**ADDENDUM - 1**

02-11-2019

ADDENDUM #: 001  
PROJECT NAME: Renovation of the Harbor Hill Complex  
PROJECT NO.: P30347  
DATE: 02-11-2019

**1 ELECTRICAL POWER PLAN**  
1/2" = 1'-0"

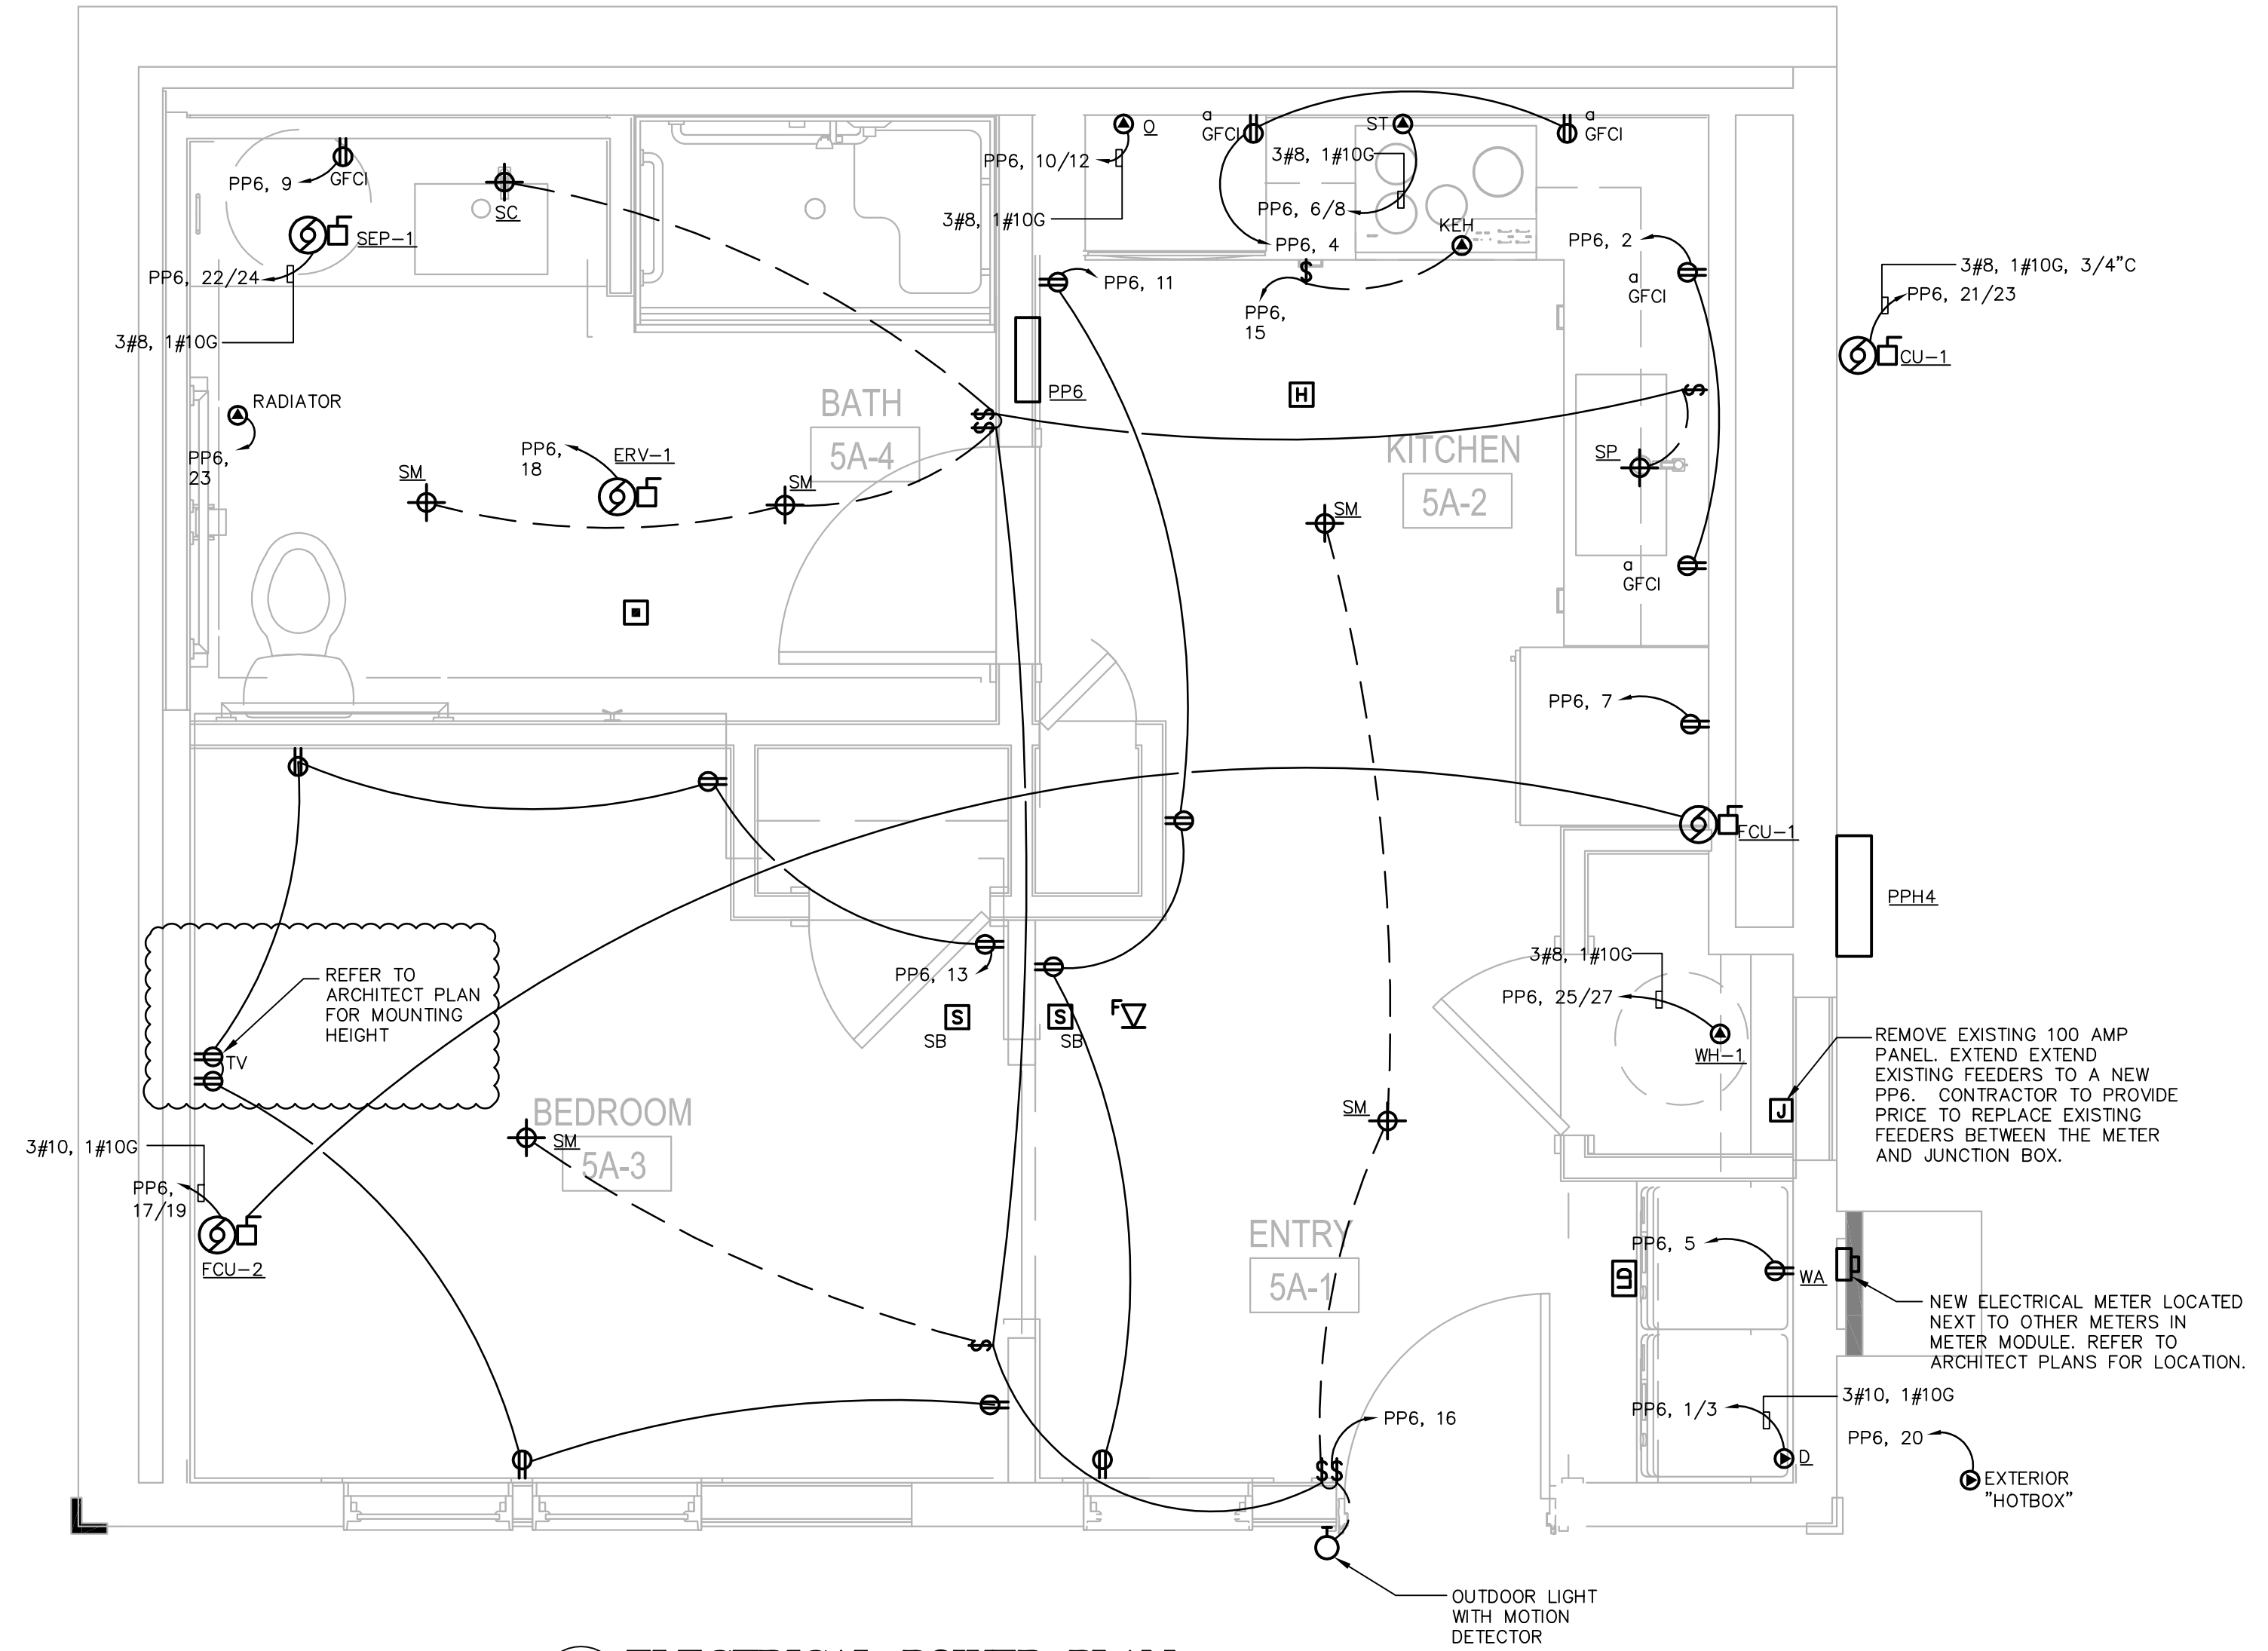
E-1.0-4                See attached drawing. TV outlet added to bedroom.  
Item 1-6
